SITE EVALUATION

FACILITY # B30579 NAME: Mike & Ryllis Kelly
 TOWNSHIP: Irving SECTION: 24
 SITE ADDRESS: Jarman Rd (D)
 PARCEL/SIZE: 2.4 acres

2.4 acres
PARCEL
D

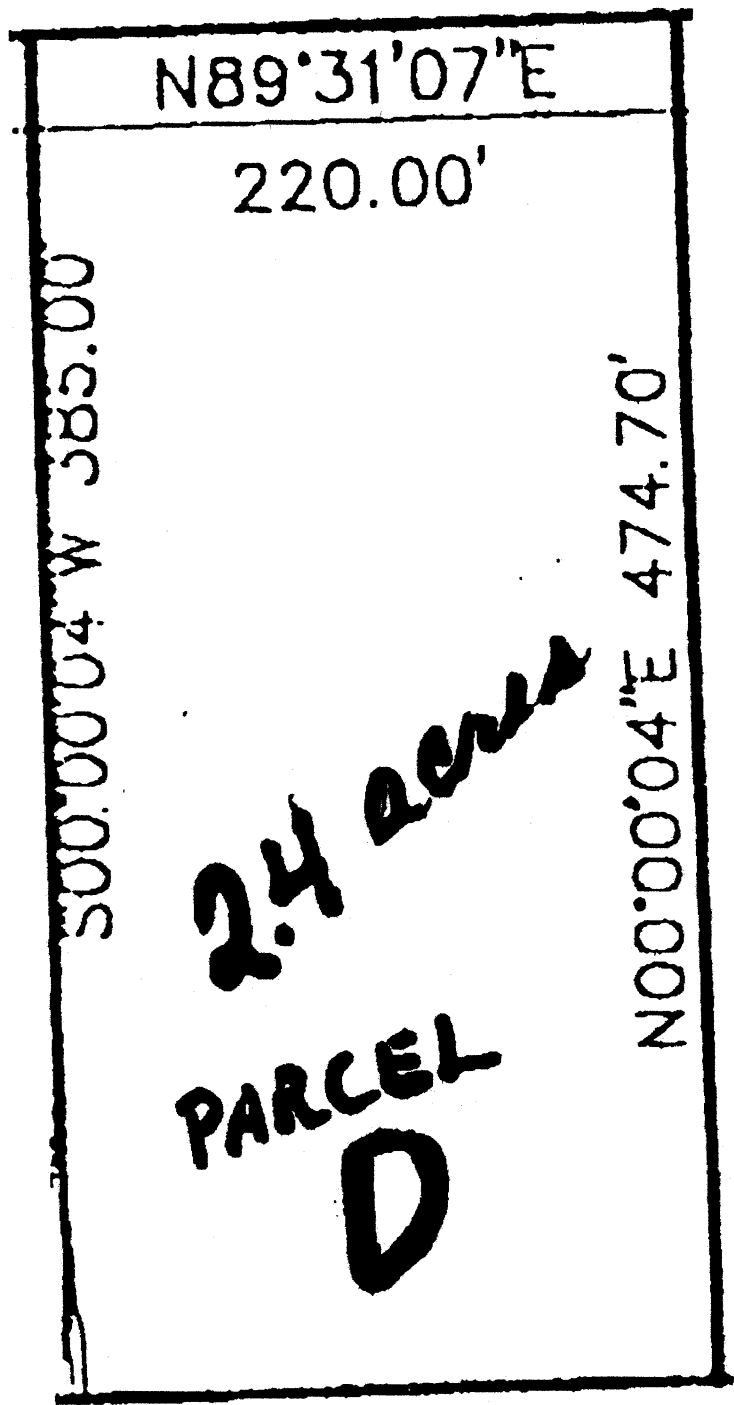
COMMENTS/STIPULATIONS: The available area of acceptable soil will limit the size of the home to 2 bedrooms with no garage disposal. ~~Additional area may be available.~~
